Golden Refit Garments Ltd. (Extension)

14th November 2016

Observations

Column Layout

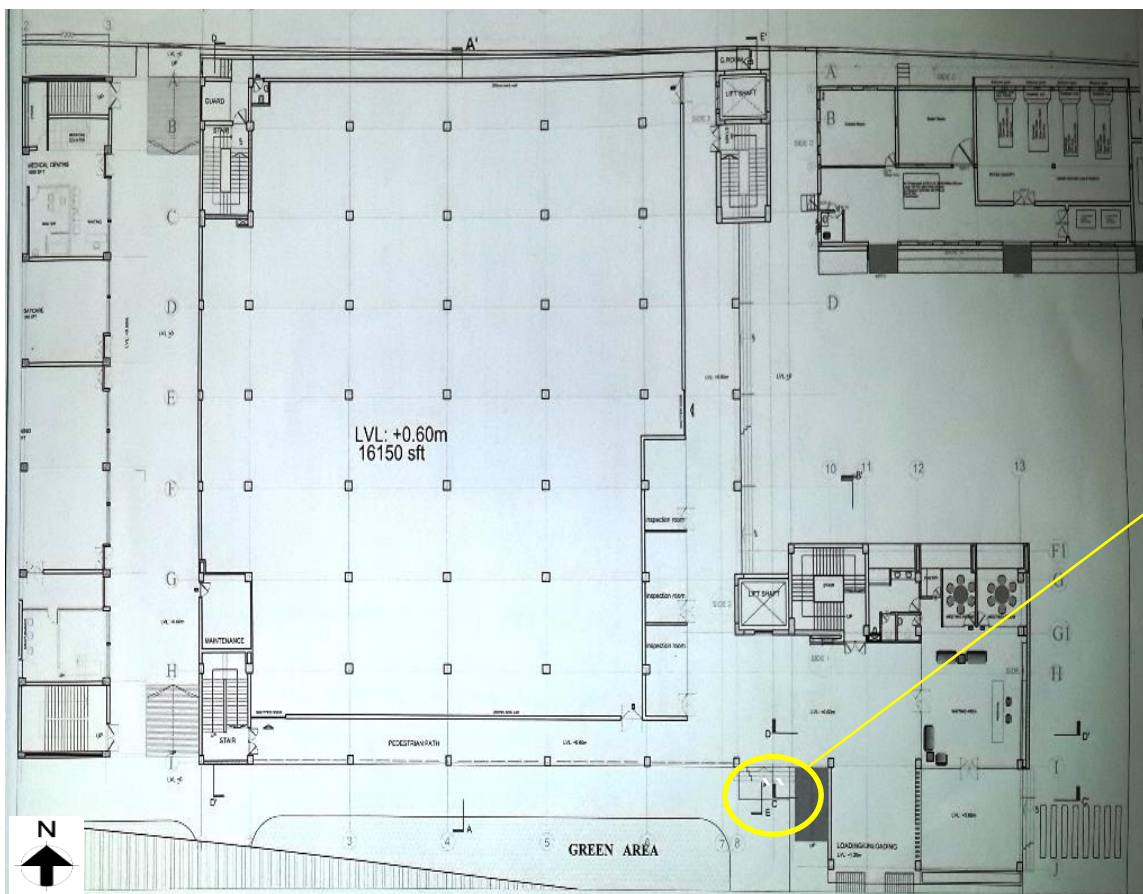
Columns susceptible to vehicle impact

Impact protection not provided to columns at loading –unloading area. Columns are susceptible to impact loading from vehicles.

Architectural Drawing of Ground floor

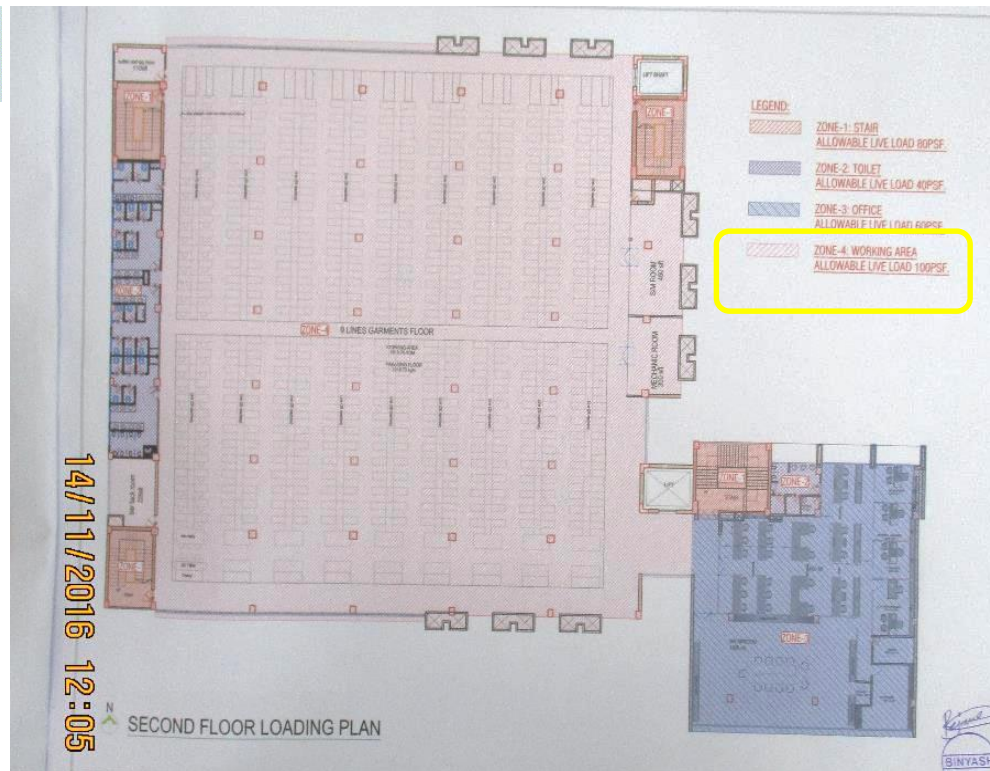
Undocumented steel canopy beside loading/unloading area

Undocumented steel canopy observed in ground floor south side beside loading/unloading area.

Prepared load plan required to be verified

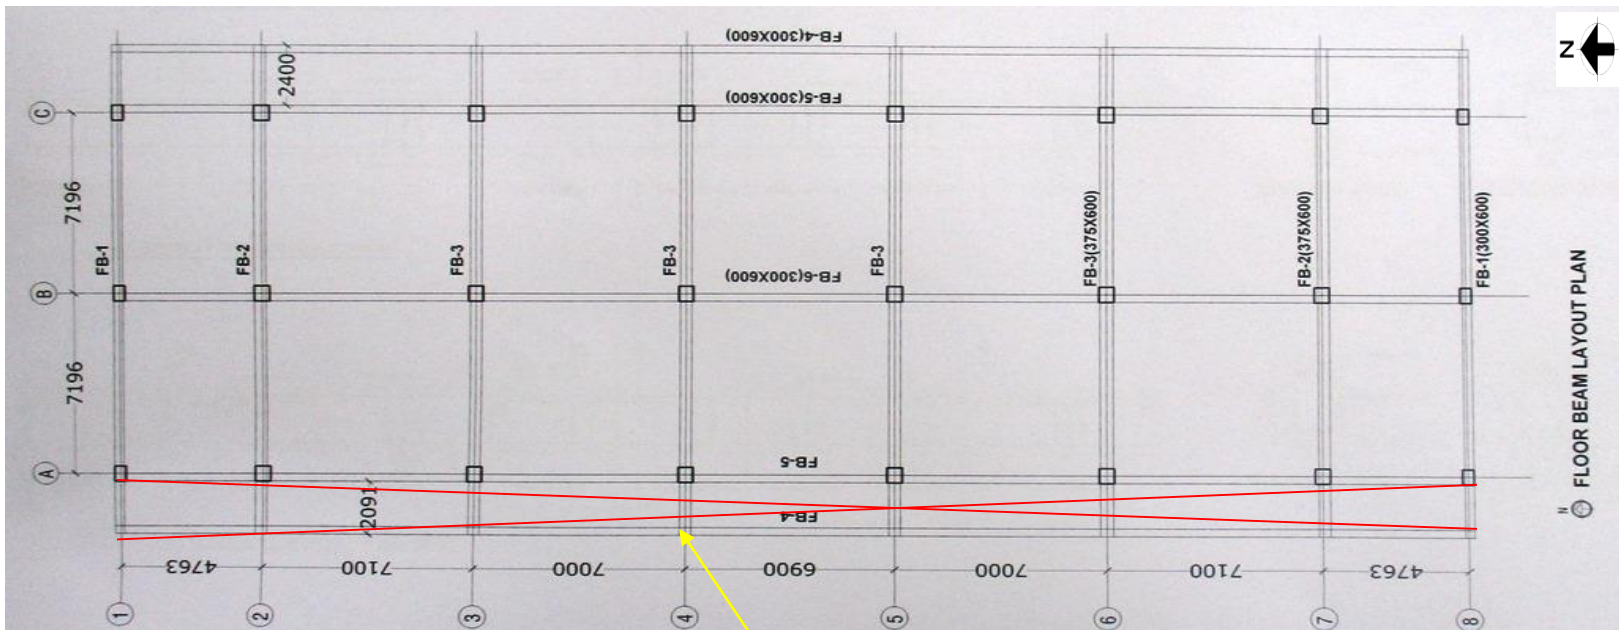
Factory is required to maintain the floor live load 2kpa until further verification by design engineer.

During inspection no over loading was observed and FOS calculation for internal column was found satisfactory considering 2kpa allowable floor live loading.
